U.S. NUCLEAR REGULATORY COMMISSION  
REGION I

Report No. 50-309/90-23

Facility: Maine Yankee Atomic Power Station

Inspection Summary: Announced safety issues inspection of the licensee's implementation of NRC Bulletin 88-04.

HPSI Minimum Flow Configuration

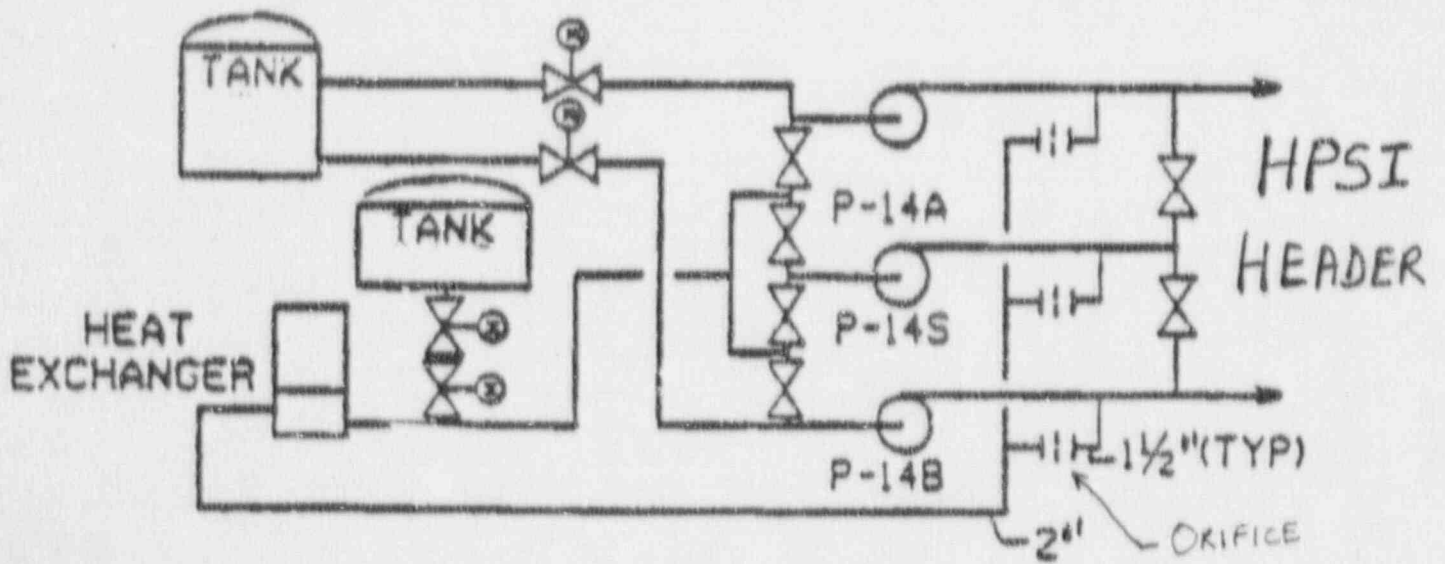
Maine Yankee's HPSI system consists of three pumps each rated for 200 gpm at 5,500 ft total discharge head (TDH). The Best Efficiency Point (BEP) for the pump is 450 gpm at 4,500 ft (TDH). Each pump discharges into the Reactor Coolant System (RCS) through a 4-inch pipe. A one and a half (1.5) inch minimum flow recirculation line provides 50 gpm Minimum Recirculation (MR) for each pump. These lines, each with a pressure breakdown orifice and a check valve, merge into a common 2-inch pipe. The common 2-inch pipe discharges into the pumps' suction pipe at the Volume Control Tank through the seal water heat exchanger. A sketch of the configuration is shown on Attachment A.

- 1) Licensee's letter to the NRC, dated January 2, 1990, identified HPSI system's worst case operation as the fill and vent mode at 64 gpm for up to 6 hours a year. The above fill and vent operation appears not to be covered by the vendor's evaluation, as the licensee's letter, dated September 22, 1988, requesting the vendor evaluation stated that such operation would not exceed 1.5 hours per year.
- 2) In the Alternate Letdown mode (over 2 hours operation) the vendor's recommended minimum flow of 128 gpm was not being met. Plant procedure 1-11-6, Chemical and Volume Control System Operation, Revision 27, limits flow in this mode to 106 gpm.

The licensee contacted the vendor to obtain confirmation that the pumps are not subjected to accelerated degradation during the above modes of operation. The licensee agreed to resolve this issue in a letter by March 15, 1991. This item remains unresolved pending completion of licensee action to demonstrate that operating the HPSI system pumps during the fill and vent operation and the alternate letdown operation discussed above does not cause accelerated pump degradation. (Unresolved item no. 90-23-01).

LPSI and CS Minimum Flow Configuration

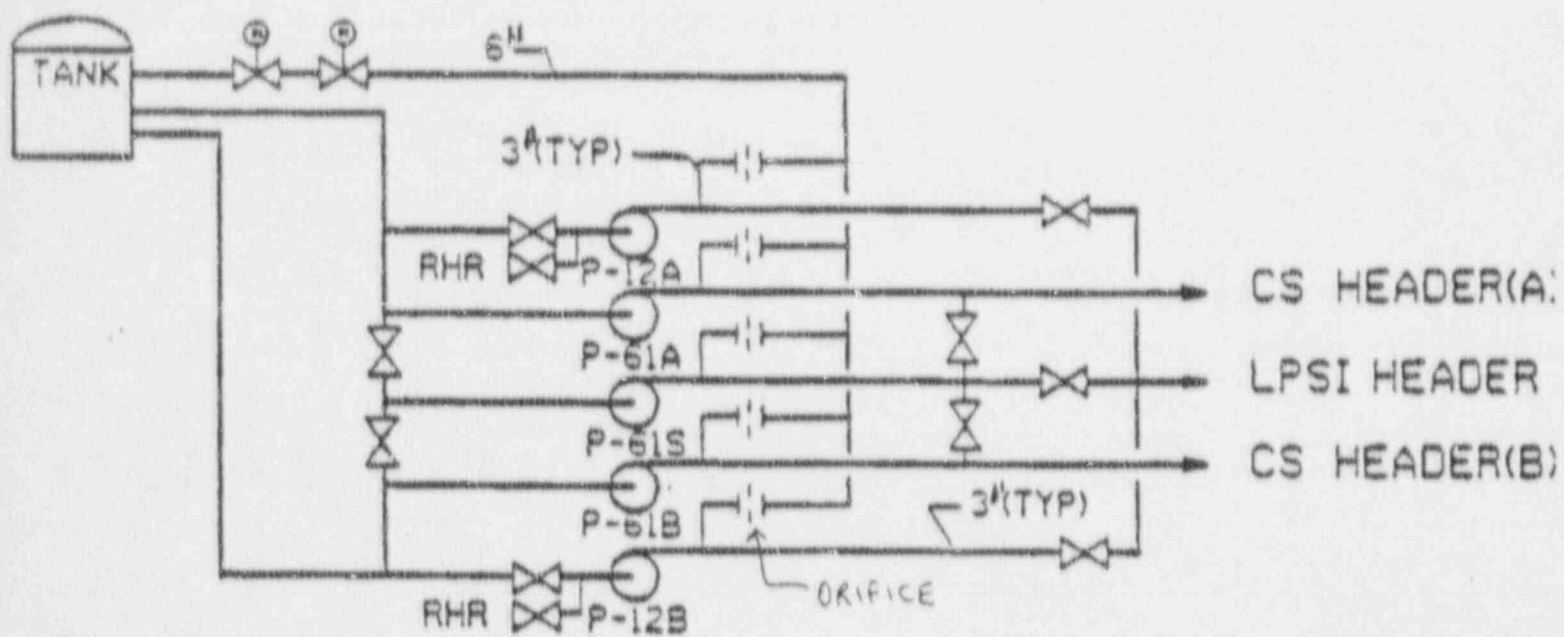
Maine Yankee's LPSI system consists of two pumps each rated for 3,000 gpm at 365 ft total discharge head (TDH) with a shutoff pressure of 430 ft (TDH). The Best Efficiency Point (BEP) for each pump is shown as 4,000 gpm at 330 ft (TDH). The pumps discharge into the RCS through a ten inch pipe. Each pump is provided with a 3-inch minimum flow recirculation line from the discharge piping upstream of the discharge check valve. Each recirculation line has a pressure breakdown orifice and a check valve. The recirculation lines for these LPSI pumps merge with those for the Containment Spray pumps into a common 6-inch line and discharge to the Refueling Water Storage Tank (RWST). A sketch of the minimum flow configuration is shown in Attachment B.

The inspector discussed the adequacy of this six inch line when four pumps (two LPSI and two CS) operate in the minimum flow recirculation mode simultaneously. This item remains unresolved pending completion of licensee's action to demonstrate the ability of this six inch line to adequately handle simultaneous operation of the LPSI and CS pumps. (Unresolved Item No. 90-23-02).

pipe upstream of the discharge check valve. Each minimum flow line has a pressure breakdown orifice and a check valve. All three recirculation lines merge with those of the LPSI pumps into a common 6-inch line. This line discharges into the RWST. A sketch of the CS recirc. system is shown on Attachment B.

Each recirculation line was designed for a flow of 425 gpm as stated by the licensee. Current surveillance tests demonstrate the capability of each line at a flow of 300 gpm. Although this flowrate is above the minimum flow of 200 gpm now specified by the pump's vendor, the inspector noted that there was a difference between the test flowrate (300 gpm) and the flowrate (425 gpm) stated in the licensee's letter dated July 7, 1988 to the NRC. Upon identification by the inspector, the licensee agreed to review this issue for resolution. This item remains unresolved pending licensee's resolution of the discrepancy in flowrates. (**Unresolved Item no. 90-23-03**).

EFW Minimum Flow Configuration

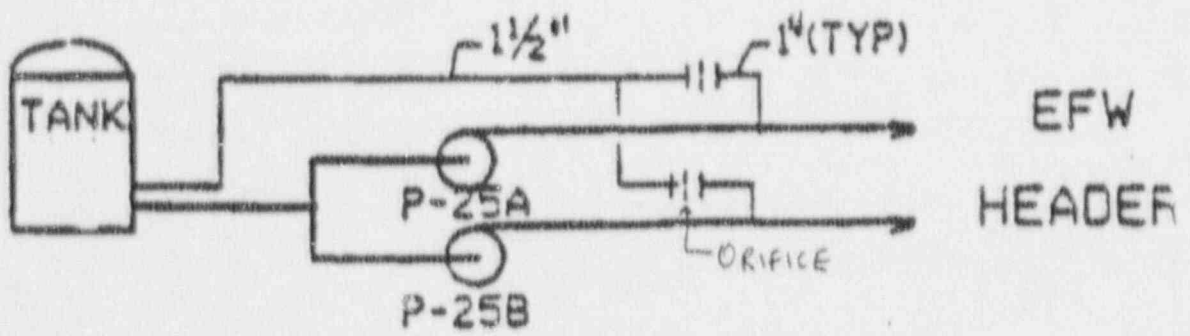
recirculation lines merge with that of the turbine driven auxiliary feedwater pump into a one and a half (1.5) inch pipe which discharges into the demineralized water storage tank. A sketch is shown on Attachment C.

The inspector noted that the pump's minimum flow limitations were not strictly controlled within those specified by the vendor. The monthly surveillance procedure (at a flowrate of 20 gpm) does not limit the pumps' run time to 15 minutes. This item remains unresolved pending completion of licensee actions to demonstrate the adequacy of 20 gpm for EFW surveillance test.

**(Unresolved Item no. 90-23-04).**
